Job	Truss	Truss Type	Qty	Ply	LOT 31 PROVIDENCE CREEK FUQUAY-VARINA, NC
24-0140-R01	R02RP1	Piggyback Base	8	1	Job Reference (optional)

Atlantic Building Components, Moncks Corner, South Carolina

REPAIR(S) REQUIRED

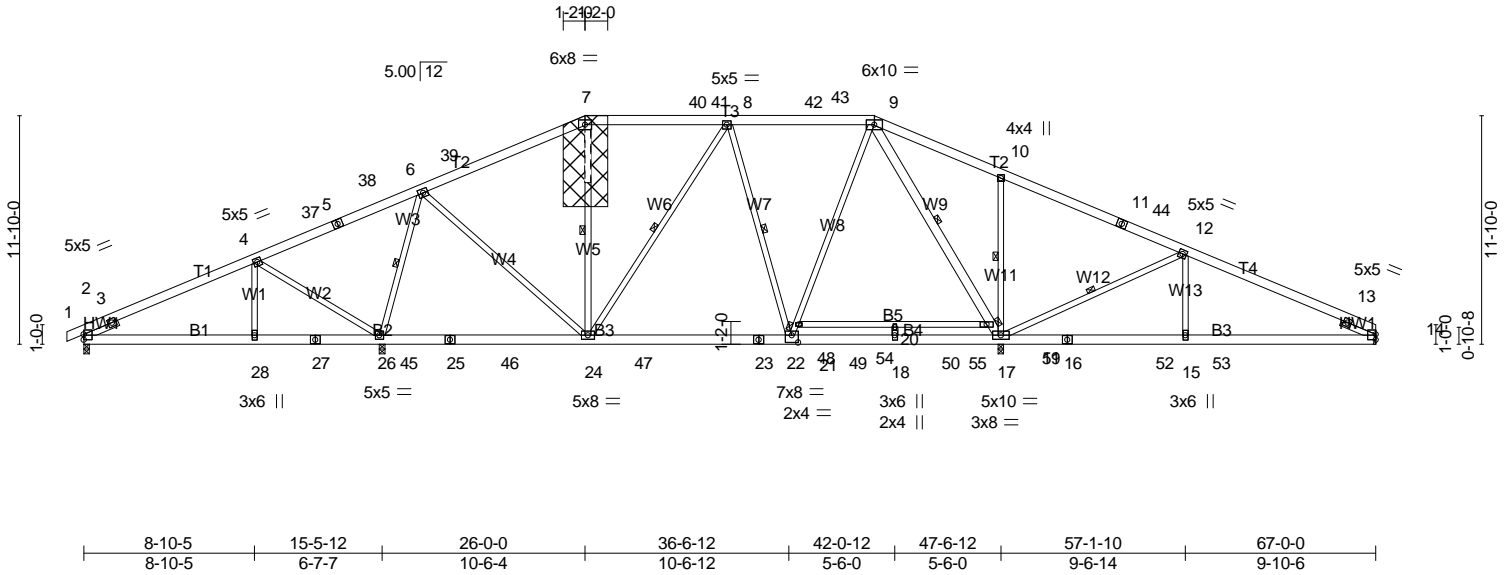
- NOTES-** (16-19)
 1) Repair Condition: web has damaged section 3-0-0 long starting 0-0-0 below joint 7.
 2) Replace damaged section cut clean with same size and grade of material. Attach 57"H X 28"W X 7/16" OSB (APA Rated Sheathing 24/16 Exposure 1) gusset to both sides of truss at joint 7 with 10d (0.131"x3") nails from each face, driven through both sheets of plywood and clinched. Connected together as follows: 2x6 - 2 rows 0-4-0 o.c., 2x4 - 1 rows 0-4-0 o.c. Face grain horizontal. Minimum 0-3-0 end distance.
 3) Repairs specified by this program will be subject to review and change.
 4) Unbalanced roof live loads have been considered for this design.
